# Thor Motor Coach Technical Service Bulletin

TSB #	TSB 25-04		
Description/Title:	TriMark Door Lock		
Affected Product Line(s):	Certain model year 2025-26 Aria & Riviera		
Service Campaign # :	RC000330		
Codes:	<b>Inspect with Repair:</b> TMCTS10120W	Document Date:	9/16/2025
Time Allowed:	<b>Inspect with Repair:</b> 0.33	Document Revision:	A

## TSB102

**Purpose:** There is a possible condition where the exterior entrance door handle mechanism can bypass the inside linkage causing a lock-out situation whereby the door cannot be opened from the exterior handle.

**Reference - Images of the existing and new designs:**

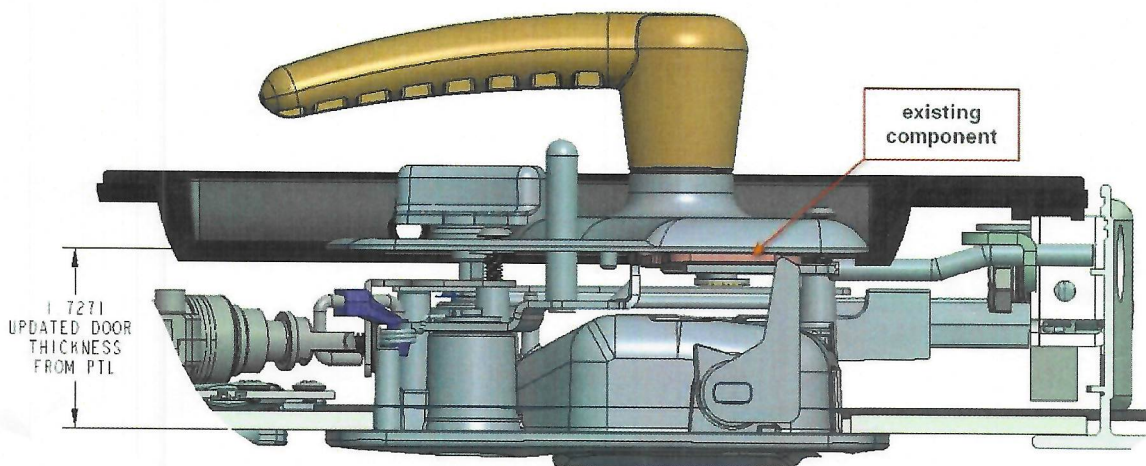
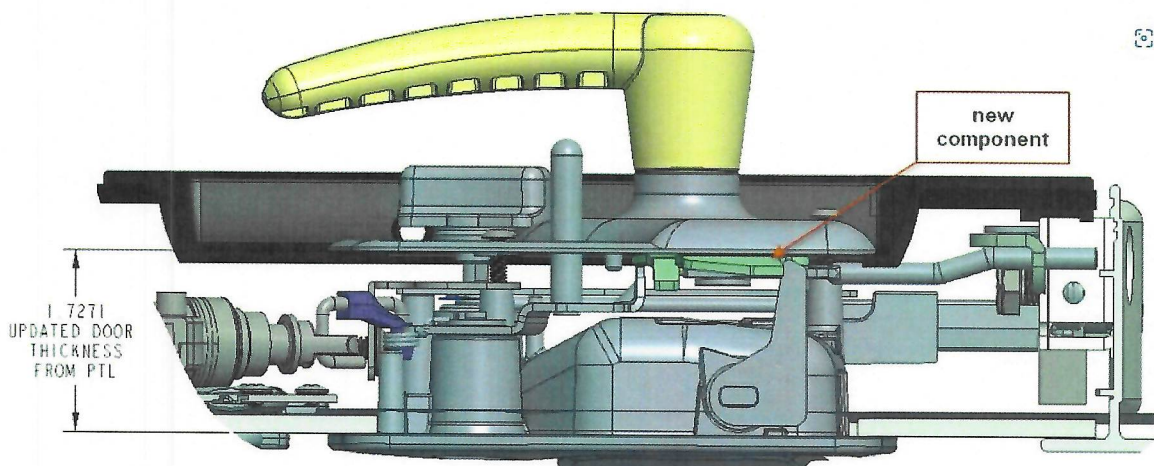
TriMark manufactured and sold to PTL, a complete RV door hardware system. PTL Engineering has reported that several Motor Coach Manufacturers have encountered issues with motorhome lockouts affecting coach owners on sold units. It was found that the pivot arm on the outside handle may pass underneath the release arm of the inside handle, due to multiple potential root causes preventing the door from opening from the outside handle. However, the interior handle is still operational from inside of the motor home.

21396-05 / 36285-02 IN 1.7271" PTL DOOR

42506-01 / 36285-02 IN 1.7271" PTL DOOR
